# PC ACTION REPORT

## C: Dunham Tract

BGE | Kerry R. Gilbert & Associates (BGE|KGA) on behalf of Mason Westgreen LP, is requesting the following amendment to the 2015 Major Thoroughfare and Freeway Plan (MTFP).

# PROPOSED 2016 MAP

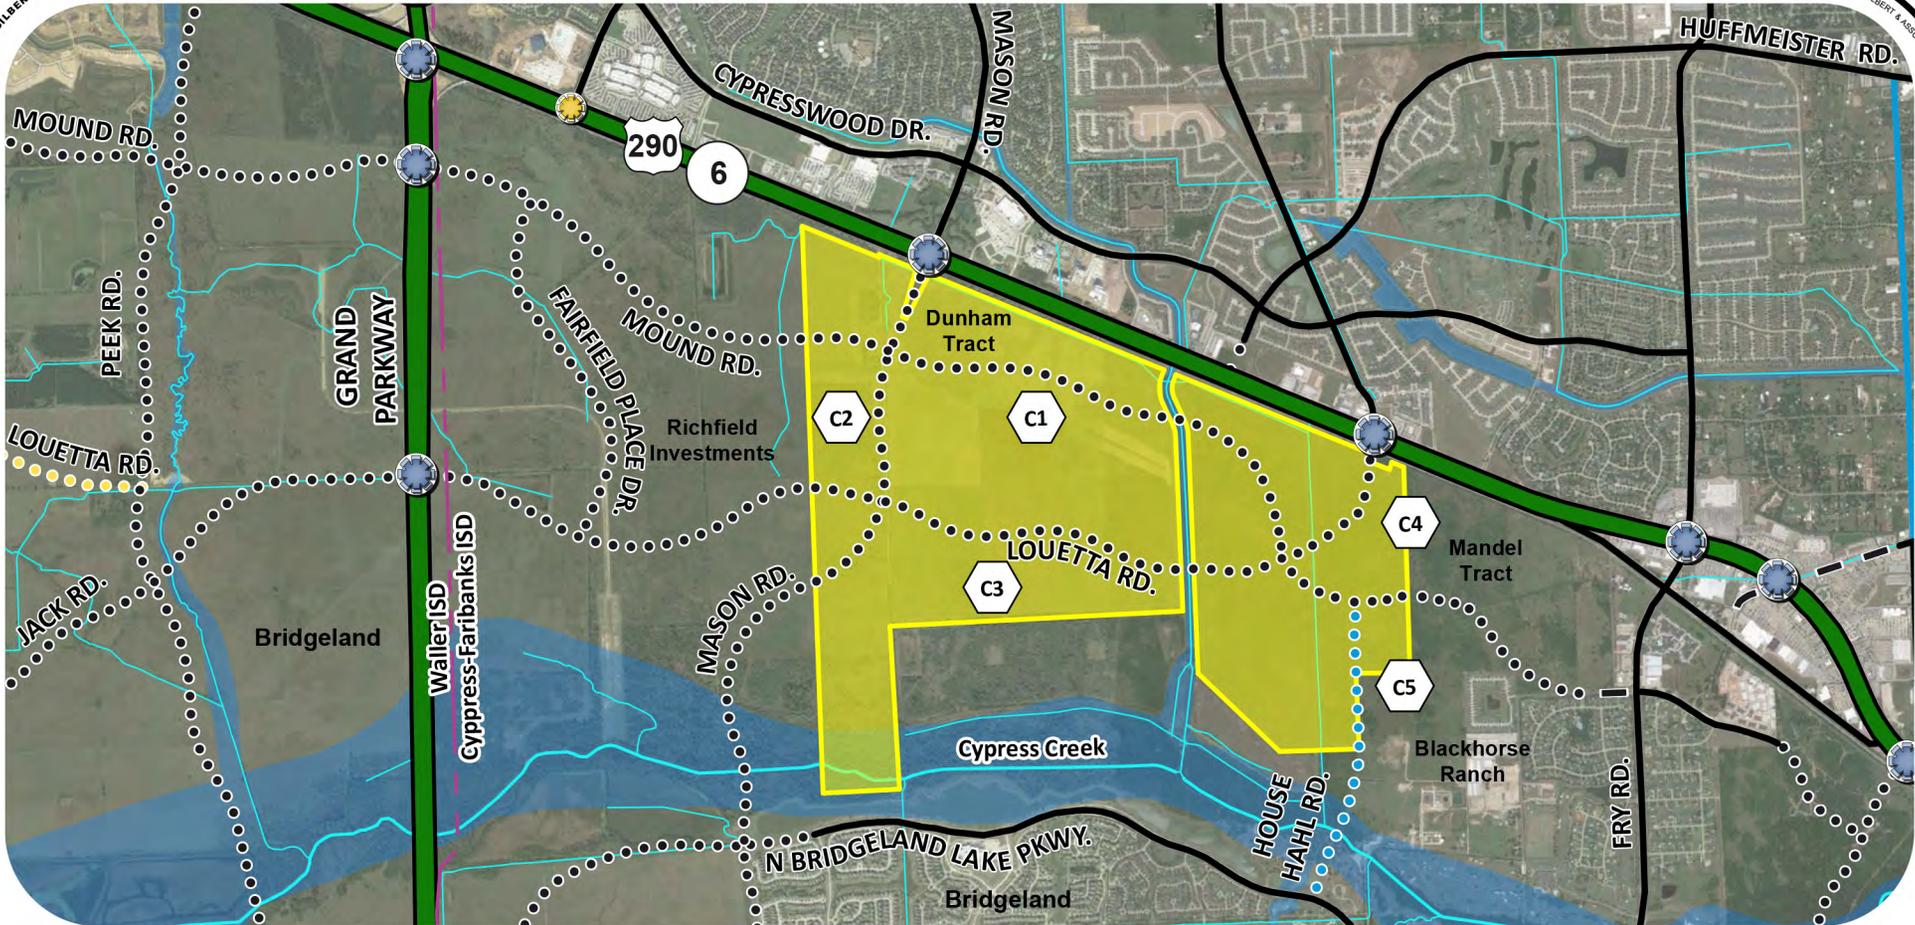
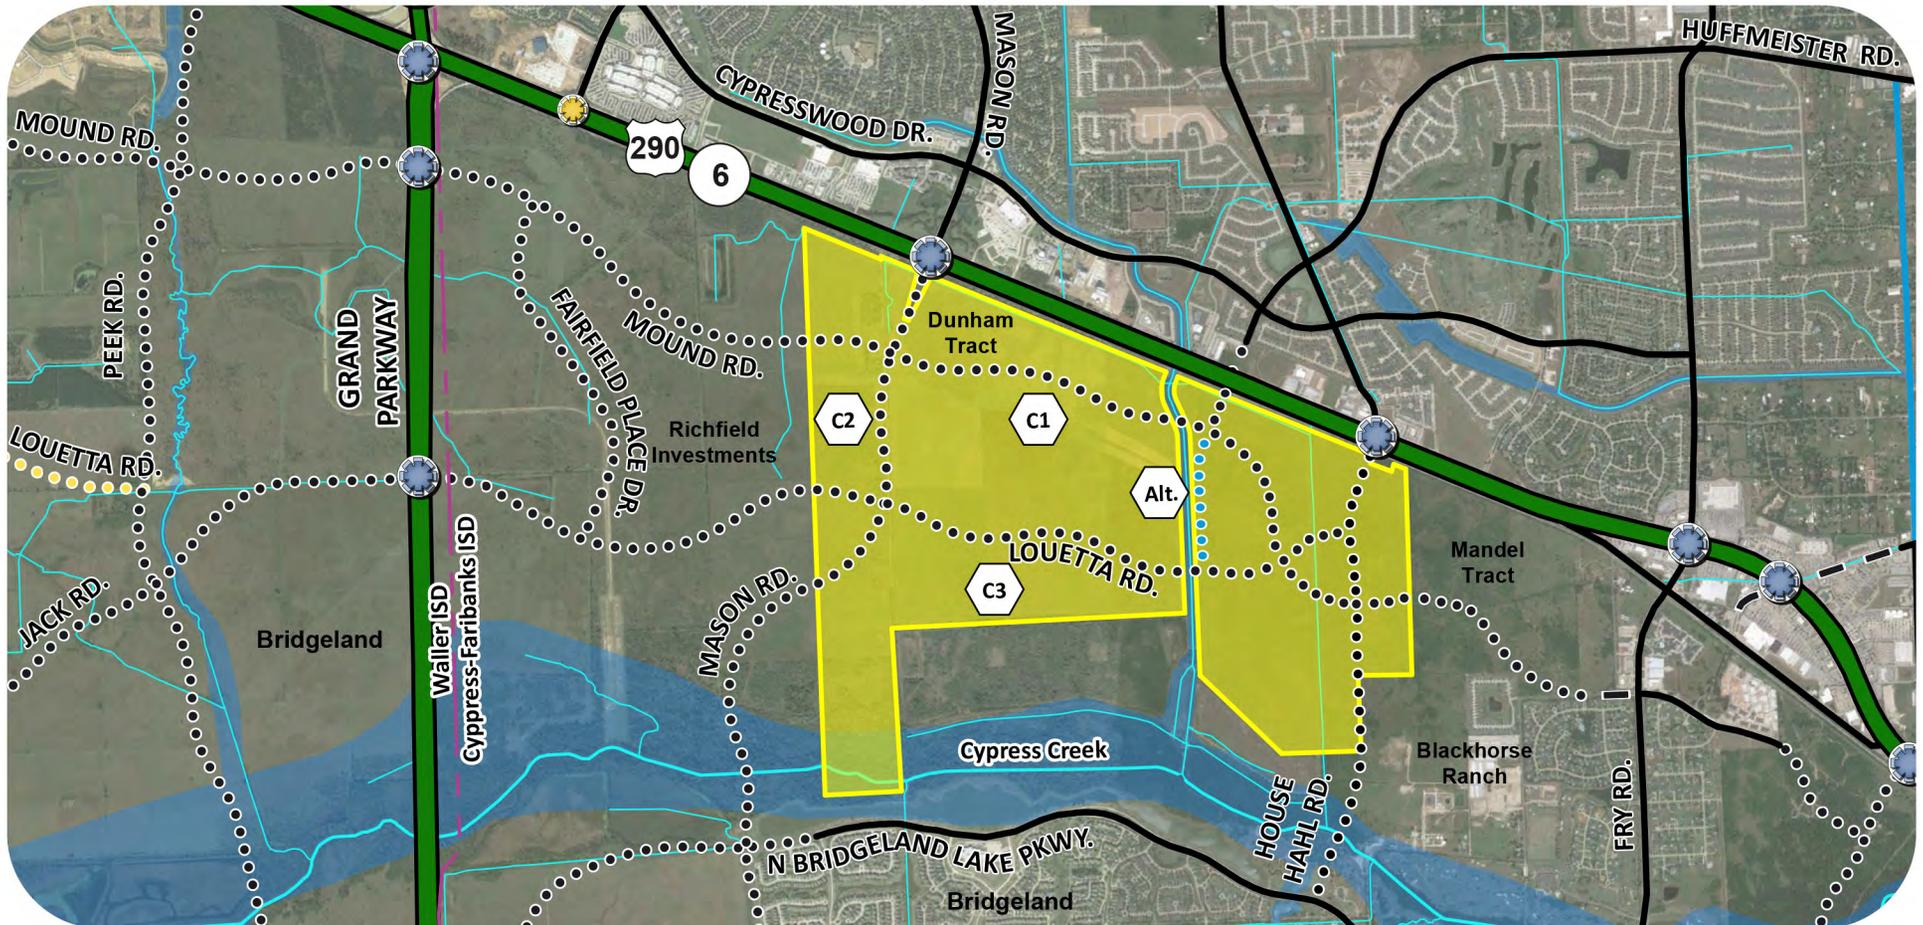
- 1) Realign Major Thoroughfare Mound Road between Fairfield Place and Fry Road
- 2) Realign Major Thoroughfare Mason Road between US 290 and North Bridgeland Lake Parkway
- 3) Realign Major Thoroughfare Louetta Road between Fairfield Place and US 290
- 4) Delete Major Thoroughfare House Hahl Road between US 290 and Mound Road
- 5) Realign Major Thoroughfare House Hahl Road between Mound Road and North Bridgeland Lake Parkway and Reclassify as a Major Collector

Staff is not supportive of the amendment to delete the proposed connection of House Hahl Road to US 290, nor the amendment to reclassify House Hahl as a Major Collector. Due to growing traffic concerns along north-south Fry Road to the east, which is nearing full-capacity, staff believes the proposed north-south connection of House Hahl to US 290 as shown on the 2015 MTFP is an important connection that can be used to relieve some of the capacity issues currently seen on Fry Road. When constructed, House Hahl Road will also be an important connection to the Bridgeland development to the south of Cypress Creek, providing this area a direct connection to US 290. For these reasons, staff recommends that Planning Commission deny the amendment requests related to House Hahl Road (C-4 & C-5).

Staff supports the proposed Louetta Road realignment, under the condition that the alignment will create a T-intersection with to-remain House Hahl Road. Due to the uncertainty of the construction of a Louetta Road interchange at US 290 in the near future, a connection of the proposed Louetta Major Thoroughfare corridor to an existing interchange at US 290 would help to provide adequate short-term mobility and highway access in this rapidly developing area. With staff's recommendation to deny the amendment request to delete House Hahl Road, it is

- **APPROVED** the realignment of Major Thoroughfare Mound Road between Fairfield Place and Fry Road on the MTFP
- **APPROVED** the realignment of Major Thoroughfare Mason Road between US 290 and North Bridgeland Lake Parkway on the MTFP

- **APPROVED** the realignment of Major Thoroughfare Louetta Road between Fairfield Place and US 290 on the MTFP, under the condition that it creates a T-intersection with to-remain House Hahl Road

- **DISAPPROVED** the deletion of Major Thoroughfare House Hahl Road between US 290 and Mound Road on the MTFP
- **DISAPPROVED** the realignment and reclassification of Major Thoroughfare House Hahl Road between Mound Road and North Bridgeland Lake Parkway on the MTFP

- **APPROVED** the staff alternative to add Unnamed Road as a new Major Thoroughfare (T-4-100) between US 290 and Mound Road and as a Major Collector (MJ-2-80) between Mound Road and Louetta Road.
